2.3 Radiation Monitoring Systems

The information in this section of the ABWR DCD, including all subsections, tables, and figures, is incorporated by reference with the following departures.

STD DEP T1 2.3-1 (Figure 2.3.1)

STD DEP T1 2.14-1 (Table 2.3.3)

Figure 2.3.1 Process Radiation Monitoring System Control Interface Diagram

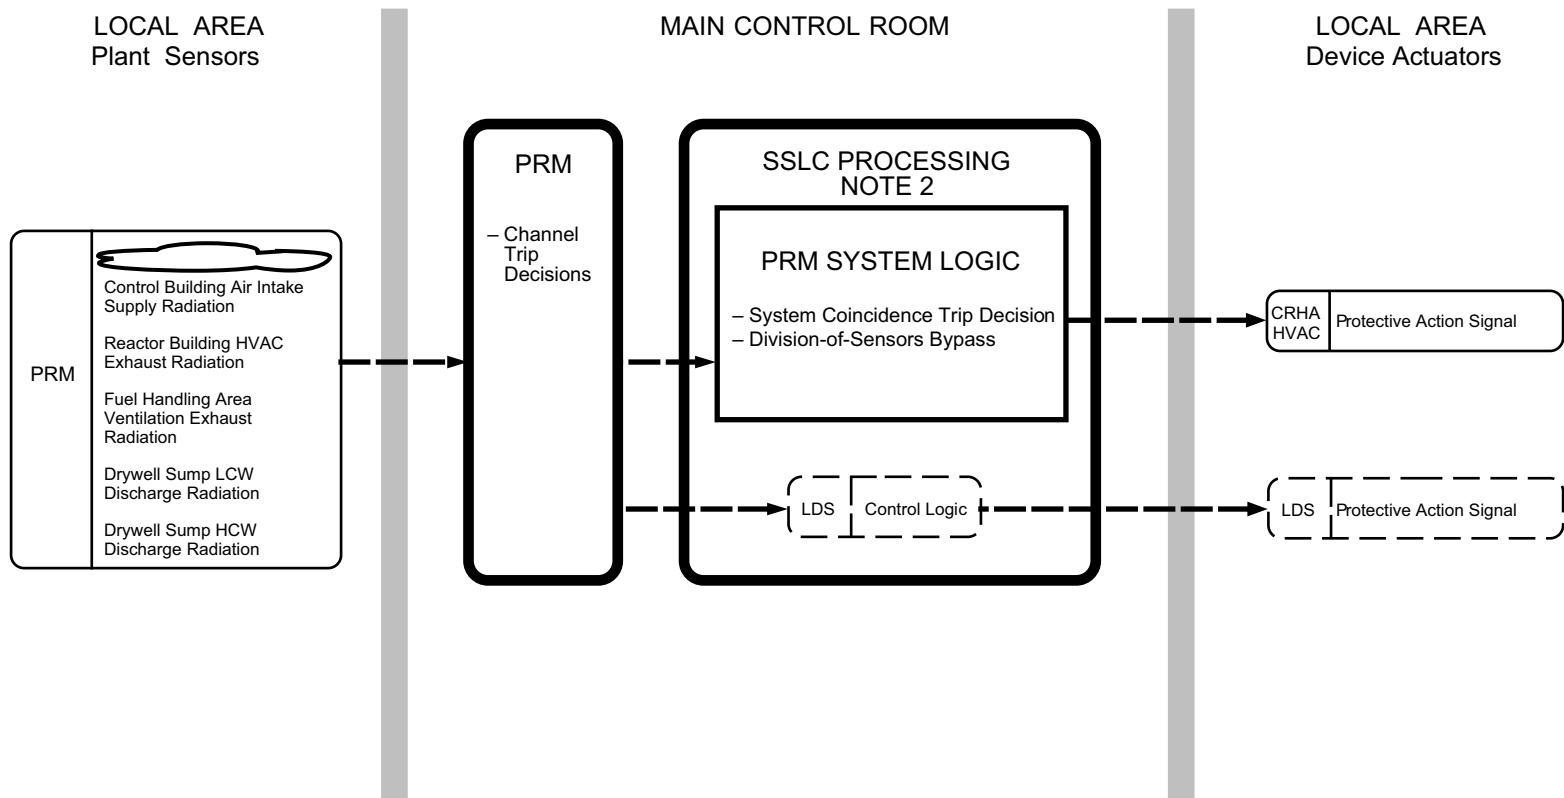
STD DEP T1 2.3-1

Portions of the PRM System are classified as Class 1E safety-related (items 42 through 5 below); the remainder are classified as non-safety-related.
